Addendum to

## ENVIRONMENTAL IMPACT ASSESSMENT

For the proposed Upgrading and Redevelopment in  
Athuruga resort, South Ari Atoll, Maldives

December 2009

Figure 1 : Additional components bringing modification to the proposed redevelopment project at Athuruga

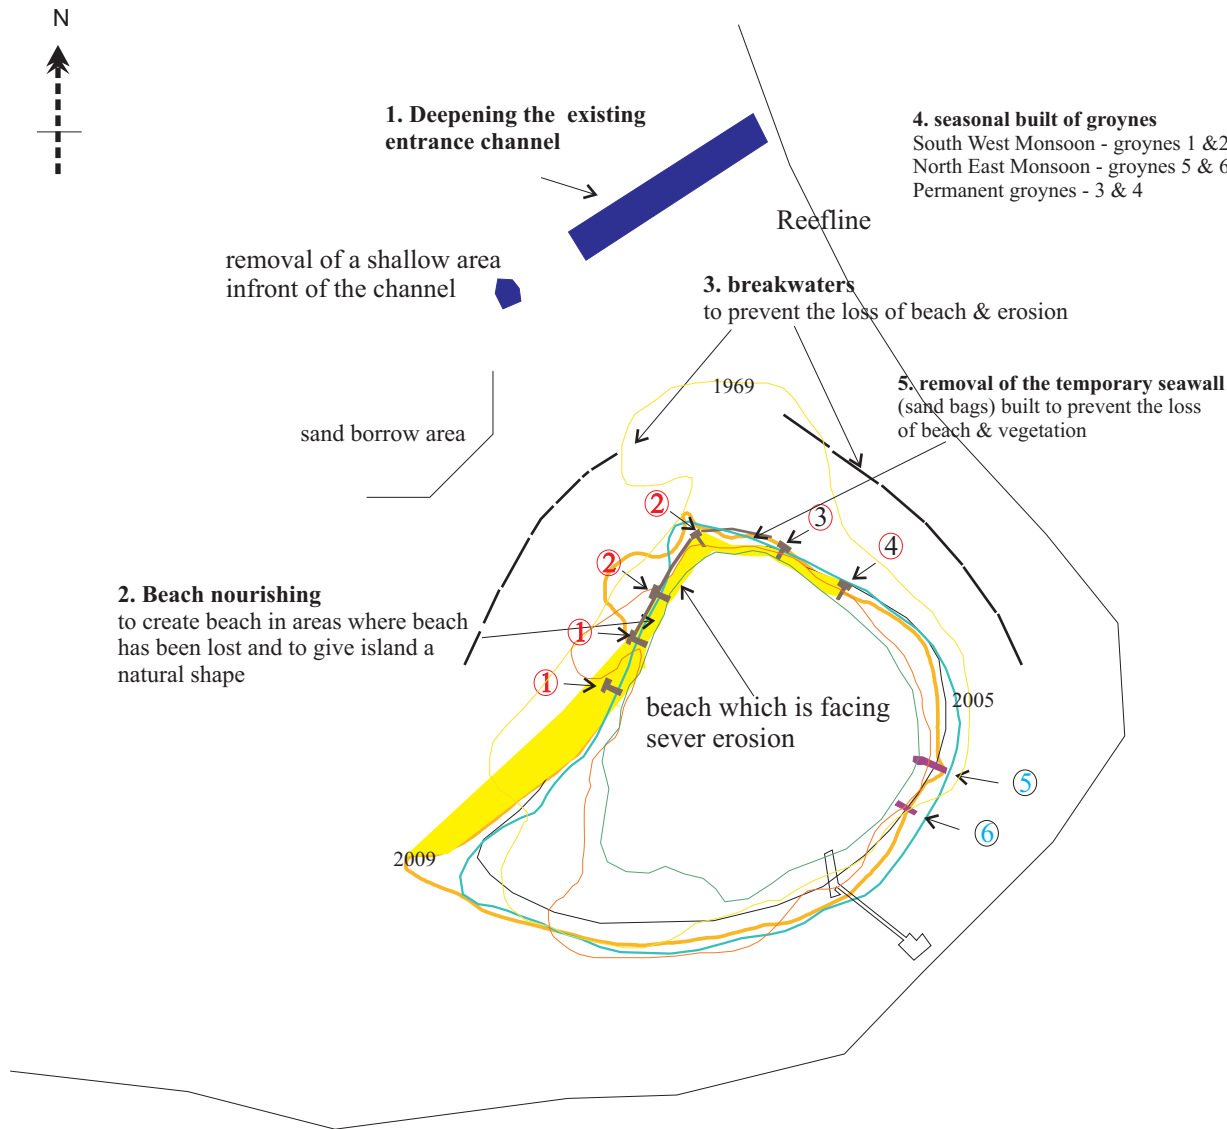
Addition to the previous plan

- Deepening the existing entrance channel
- Undertaking the coastal protection component including construction of the groynes
- Nourishment of eroded beach
- Construction of breakwater
- Reusing of corals from demolition wastes as an effective waste management strategy
- Relocation of the proposed overwater restaurant from the northern side of the walkway jetty to the southern side.

Omission from the previous plan

- Reducing the number of over water bungalows from 25 to 23.
- Reducing the number of house-keeping huts on the walkway jetty from 3 to 2.
- Not developing the over-water spa in the southern side of the walkway jetty

The existing entrance channel located on north side of the island has become shallow and has average depth of -1.0 m in low tide. It is proposed that the existing channel would be deepened to have a depth of -3.0 at mean sea level. It is estimated that 2,400 m<sup>3</sup> of sand would be excavated from this site.

Erosion is severe on north eastern corner of the island and it is estimated that Athuruga has lost 4,016.05 m<sup>2</sup> of beach when compared to the registered land area of the island. It is proposed that 2,400 m<sup>3</sup> of sand would be excavated from the entrance channel and 4,500 m<sup>3</sup> of additional sand would be pumped from the borrow area as shown in figure

It is also proposed to build 350 m of breakwater on north and north western side of the island to prevent further loss of beach, vegetation and beach villas. The materials for the breakwaters would be either rock boulders, geotextile bags filled with sand or structures made from concrete

The beach of Athuruga has been managed over the past two decades by seasonal placement of the groynes at different locations of the island. Hence it is proposed that these groynes 1 & 2 be built before the beginning of South West Monsoon (April), groynes 5 & 6 before the beginning of North East Monsoon (November) and groynes 3 & 4 permanently. The materials for the groynes could either be coral rubbles which is presently used or concrete structures that can be easily transported from one location to another

Figure 2: cross-sectional design of a groyne

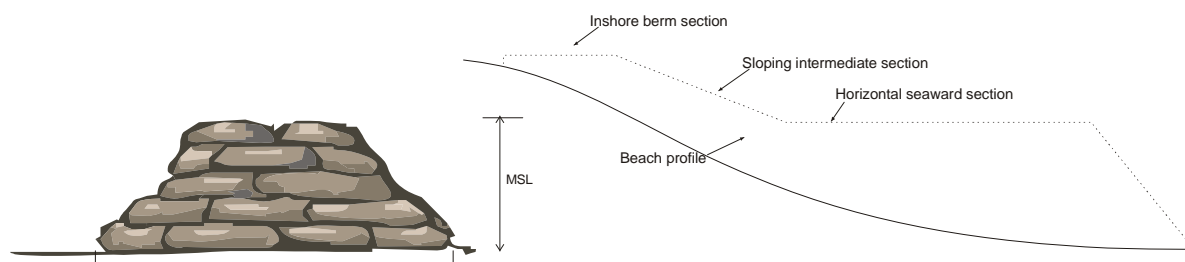
The gap between groynes is usually about two or three groyne lengths, where groyne length is defined as the distance from the beach berm crest to the groyne's seaward end. Groyne spacing is often selected based on an analysis of desired shoreline alignment following groyne construction, which depends on the wave and long-shore transport at site. Shoreline alignment following groyne construction depends mainly on prevailing wind direction and subsequent incident waves. When incident wave crests are nearly parallel larger groyne spacing can be used; when incident wave crests make a larger angle with the shoreline, closer groyne spacing is required. In the case of Athuruga, the wave crests on the northern and western beaches shores are primarily parallel to the shoreline. Therefore, it is proposed to keep groynes as far away as possible given the short length that can be achieved. This has been observed to function in the past years. The effectiveness of the proposed groynes will be assessed in the monitoring programme.

The design of the groynes is given in Figure 1. These design considerations take into account existing long-shore currents and wave overtopping. The crest of the groynes is based on the "significant wave height". However, under calmer conditions with low crested waves, as is the case in Athuruga, structures are designed to allow for overtopping. Overtopping often helps to minimize the effects of stagnation in the lee of the breakwater thereby improving water quality in the leeward side. In fact, a significant increase in strength of the crest can be achieved by careful placement of the armoured rocks to ensure good interlocking and by the use of gabion boxes or wire mesh in case of rubble structures.

**Figure 3: fill profile for the nourished area**

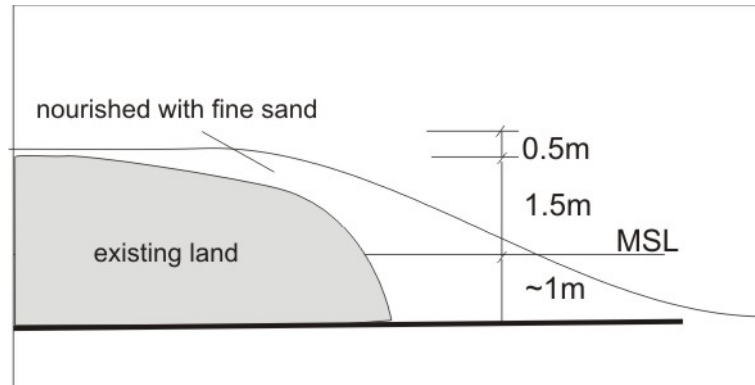
The main problem with the beach face is that the beach face has not been nourished with fine sand to maintain the loss that had occurred due to erosion. Hence, it is proposed to replenish the beach with 6,900 m<sup>3</sup> of beach sand. The sand would be borrowed from the shallow lagoon west of the island. The replenishment would be carried out so that the berm at the replenished area would have a height of at least 0.5m. Fill profile for beaches around the nourished area on the north and western side of the island are shown in Figure 3.

## New Site Plan

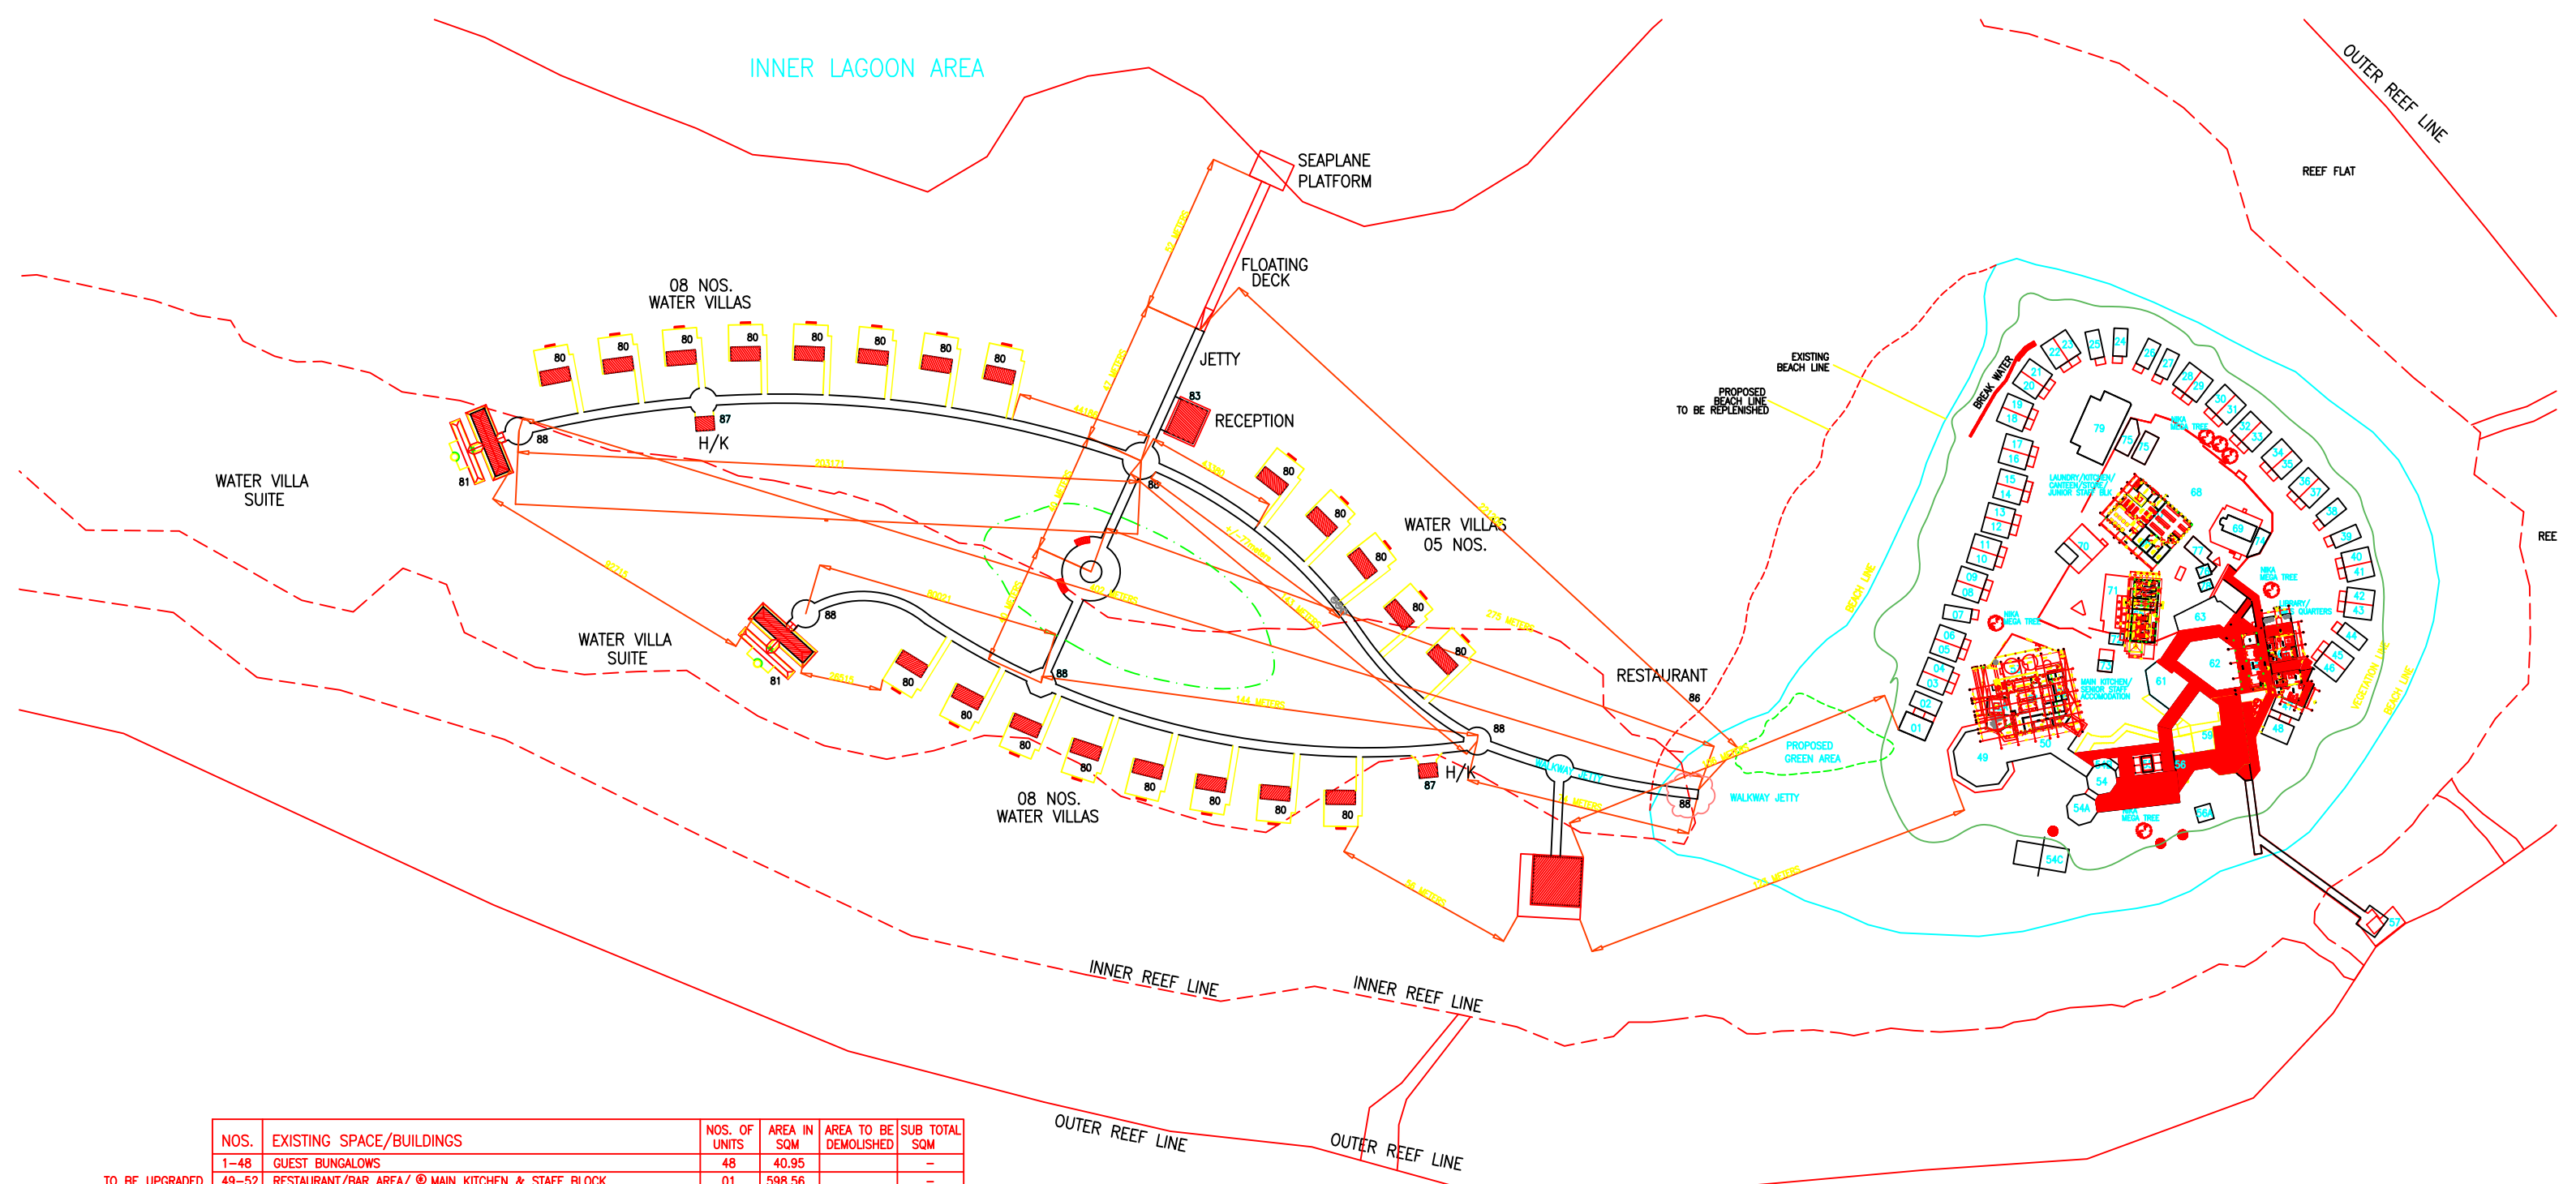
NOS.	PROPOSED SPACE/BUILDINGS	NOS. OF UNITS	AREA IN SQM		SUB TOTAL SQM
80	PROPOSED WATER BUNGALOWS	21	42.75		897.75
81	PROPOSED WATER BUNGALOW SUITE	02	120.99		241.98
83	PROPOSED RECEPTION	01	89.35		89.35
84	PROPOSED LAGOON SPA	01	228.98	OMITTED	-
85	PROPOSED BAR	01	89.35	OMITTED	-
86	PROPOSED RESTAURANT	01	237.15		237.15
87	PROPOSED HOUSKEEPING HUT	03	27.00		81.00
88	PROPOSED BUGGY CART ROUND-BOUT	01	-		-
PROPOSED TOTAL BUILD UP AREA					1547.23
TOTAL EXISTING BUILD UP AREA AFTER DEMOLITIONS					4951.86
TOTAL PROPOSED BUILD UP AREA					6499.09
